Response Under 37 C.F.R. §1.111  
Serial No.: 10/820,438  
Response dated: March 10, 2006  
In reply to the Office action mailed: November 10, 2005

### ***Amendments to the Drawings***

### **Remarks**

FIG. 2

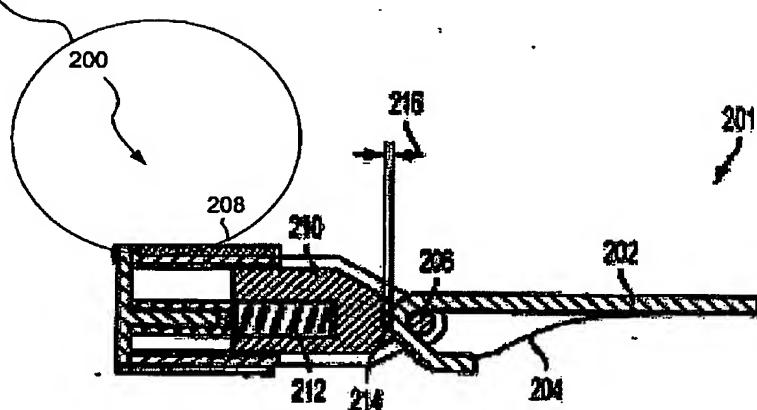
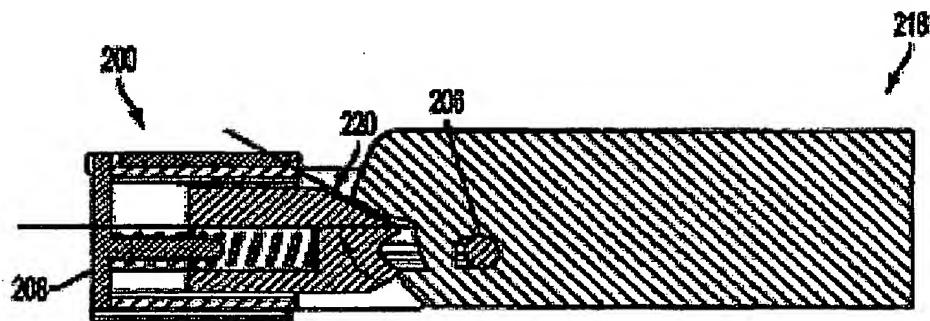
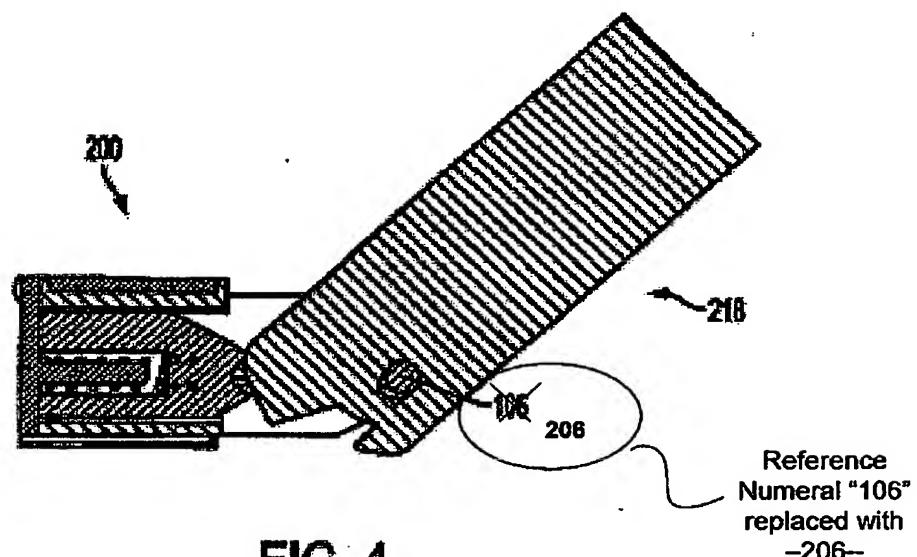
FIG. 2 has been amended to add the reference numerals 200 and 208.

FIGS 2, 4, and 10 were objected to for not including reference signs mentioned in the specification. These figures have been amended to add the missing reference numerals, or where appropriate to replace an incorrect reference numeral with the proper reference numeral. The amendments are called out in the Annotated Sheets and reflected in the Replacement Sheets, appended hereto. No new matter is believed added by these amendments.

**FIG. 4**

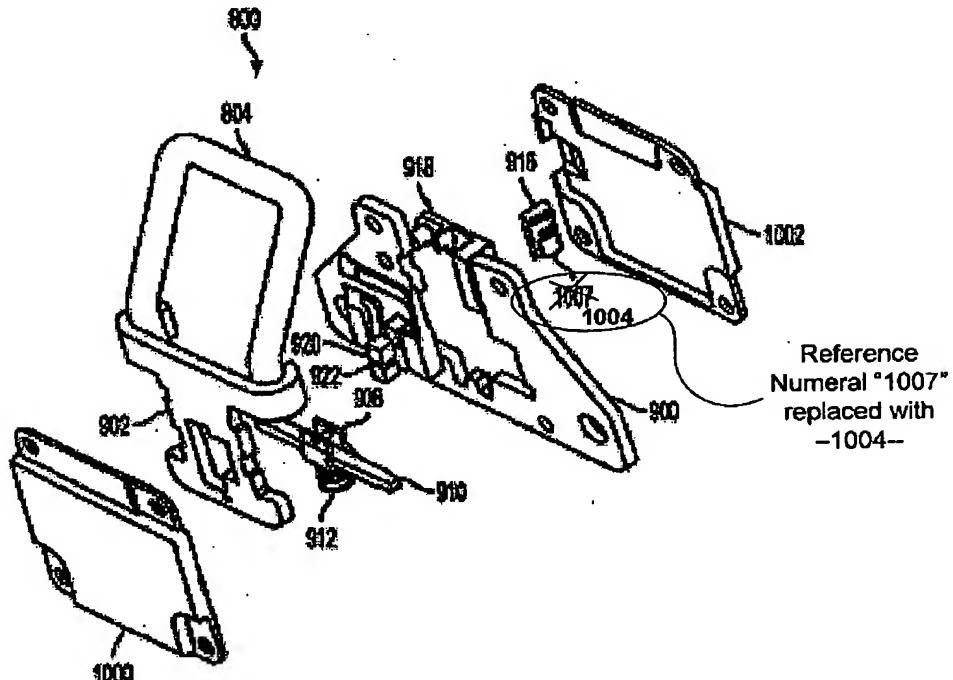
FIG. 4 has been amended to replace the reference numeral "106" with --206--.

FIG. 19

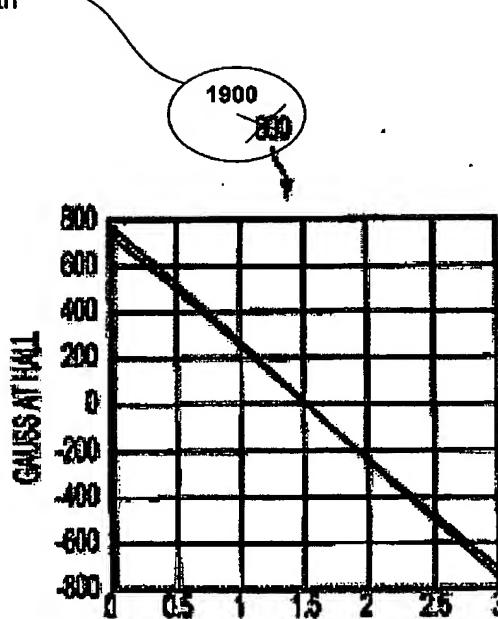
FIG. 19 has been amended to replace the reference numeral "800" with --1900--.

FIG. 19 has been amended herein to replace the reference numeral "800" with the reference numeral "1900". The specification has been amended at paragraph [0057] to read consistently. No new matter is believed added.

Reference  
Numeral "800"  
Replaced with  
-1900-
